# Overview on Proposal

## ECE/TRANS/WP.29/GRSP/2009/6

**Thomas Herpich**  
**May 2009**

## Testing sensitivity for strap movement

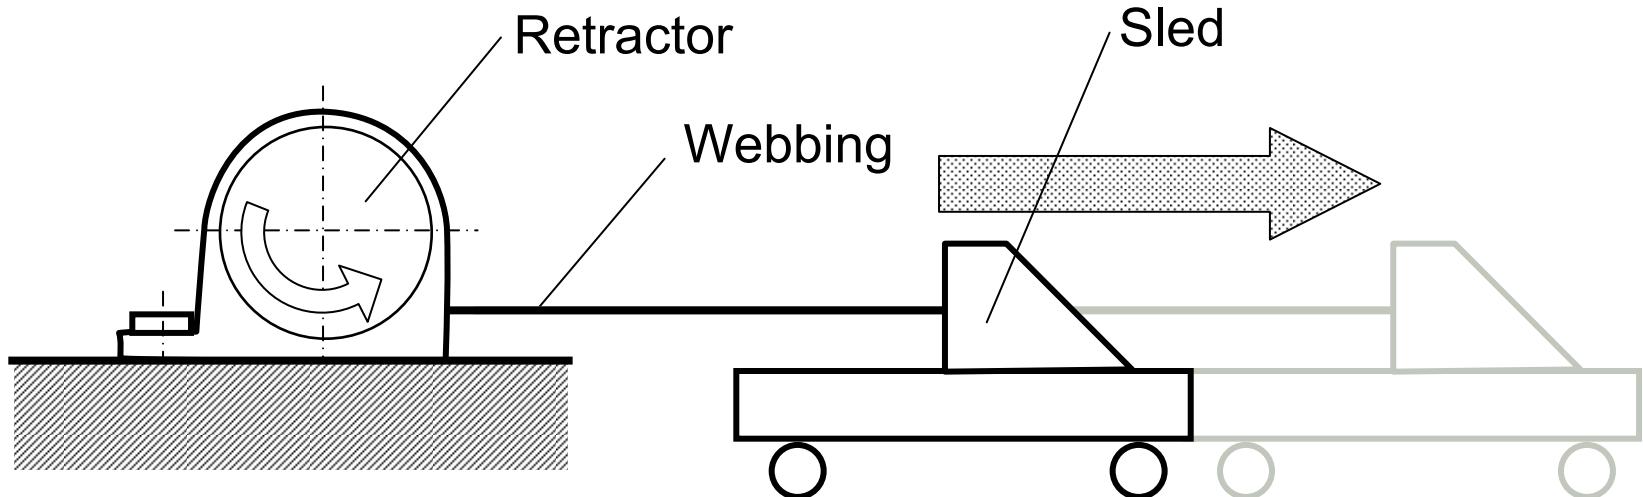
- Spool storage 300 mm
- To be tested in the direction of installation
- Test acceleration to be reached within 25g/s and 150g/s before 5 mm webbing is withdrawn
- Locking must have occurred between 0.8g / 1.0g\* and 2.0g

# Inconsistency in Testing Strap Extraction

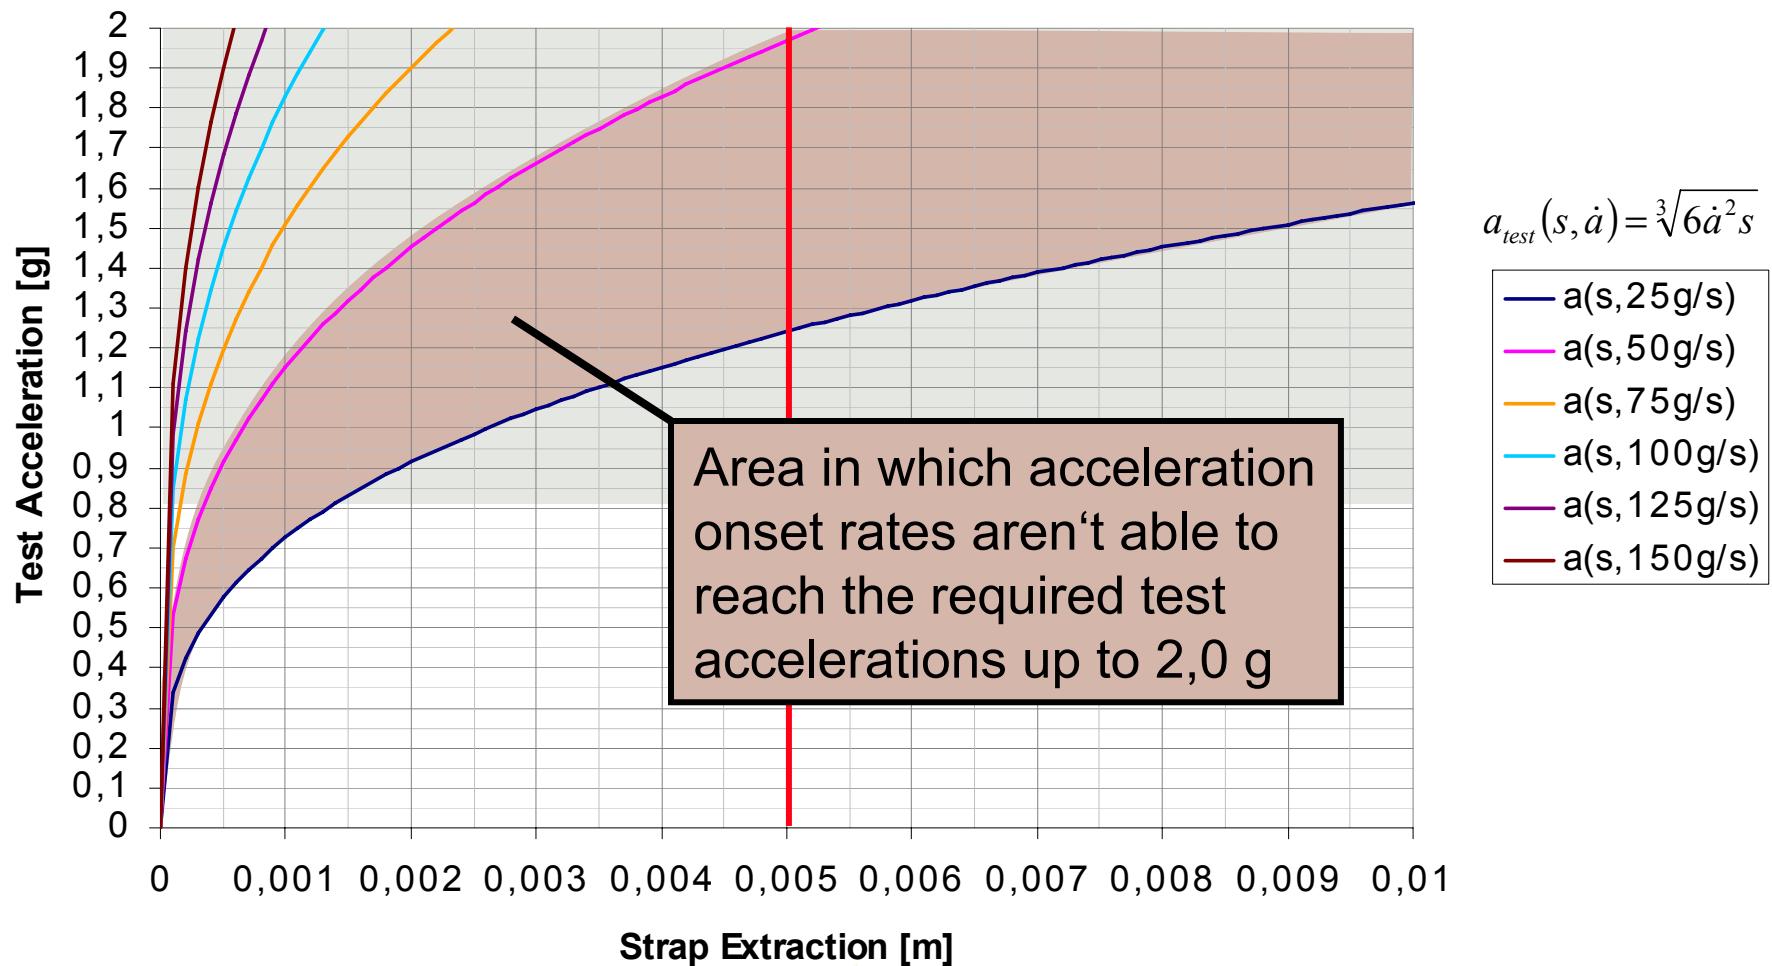
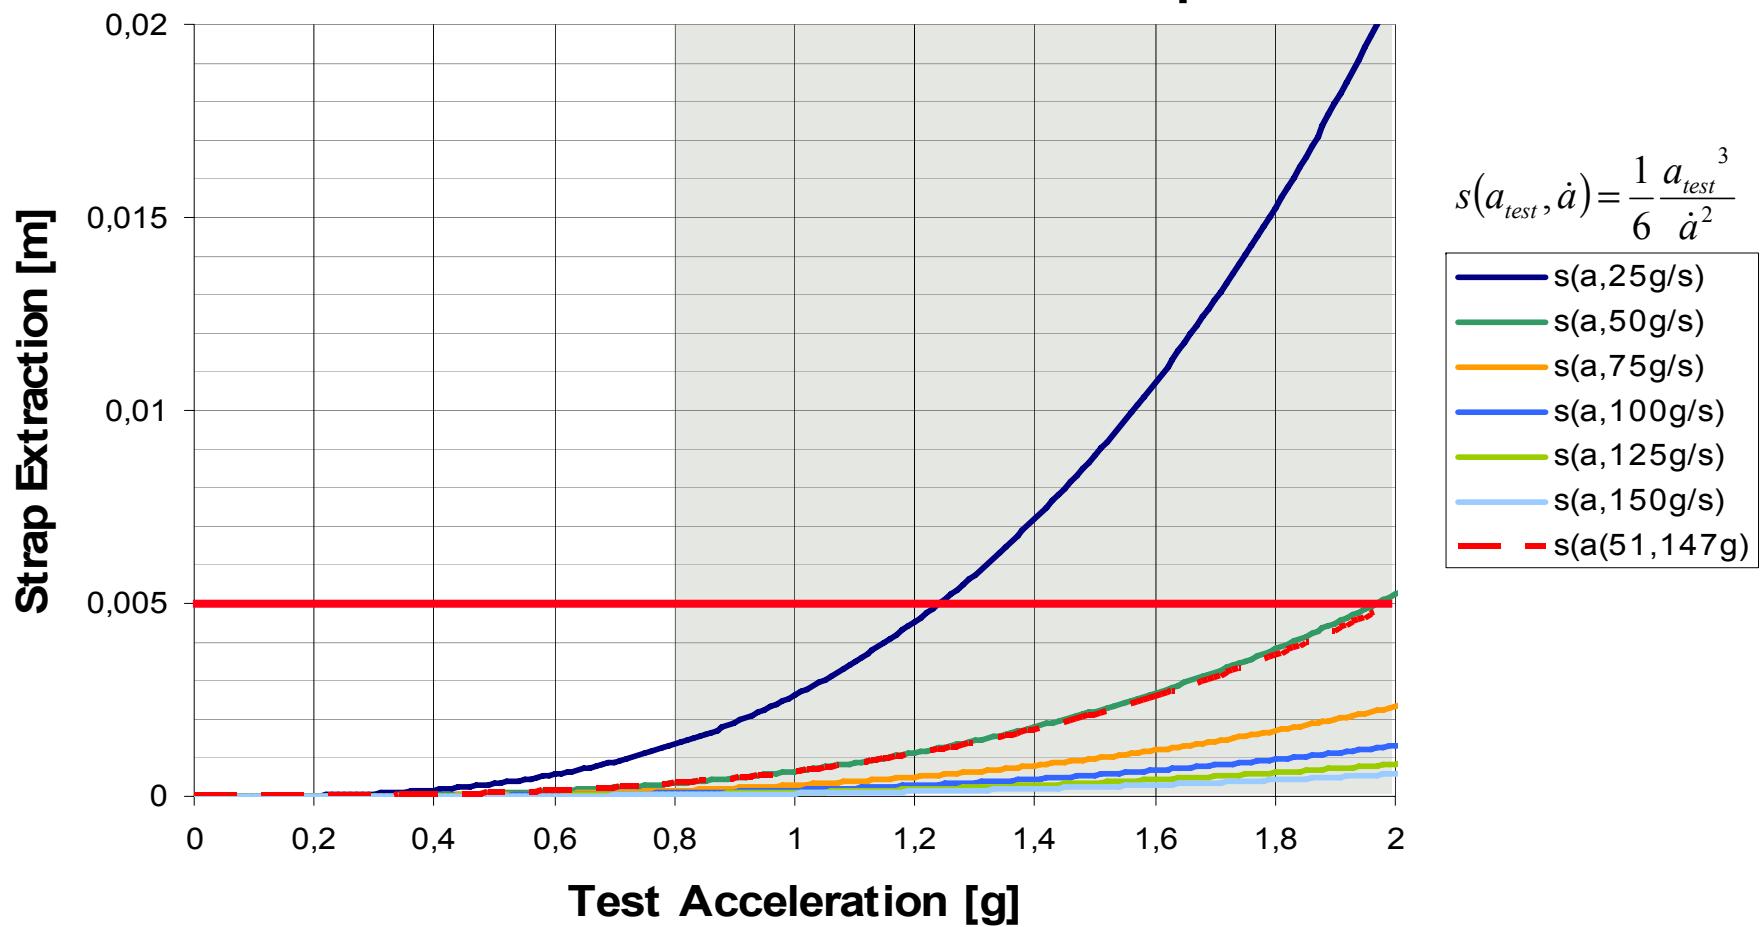
**Strap extraction when test acceleration has been reached after acceleration onset phase.**

Strap extraction when test acceleration has been reached after acceleration onset phase.

The design of any such test apparatus shall ensure that the required acceleration is given before the webbing is withdrawn out of the retractor by more than 5 mm and that the withdrawal takes place at an average rate of increase of acceleration

of at least **55 g/s** 4/ and not more than 150 g/s 4/ in testing **sensitivity for strap movement** and

of at least **25 g/s** 4/ and not more than 150 g/s 4/ in testing **sensitivity for vehicle deceleration**.
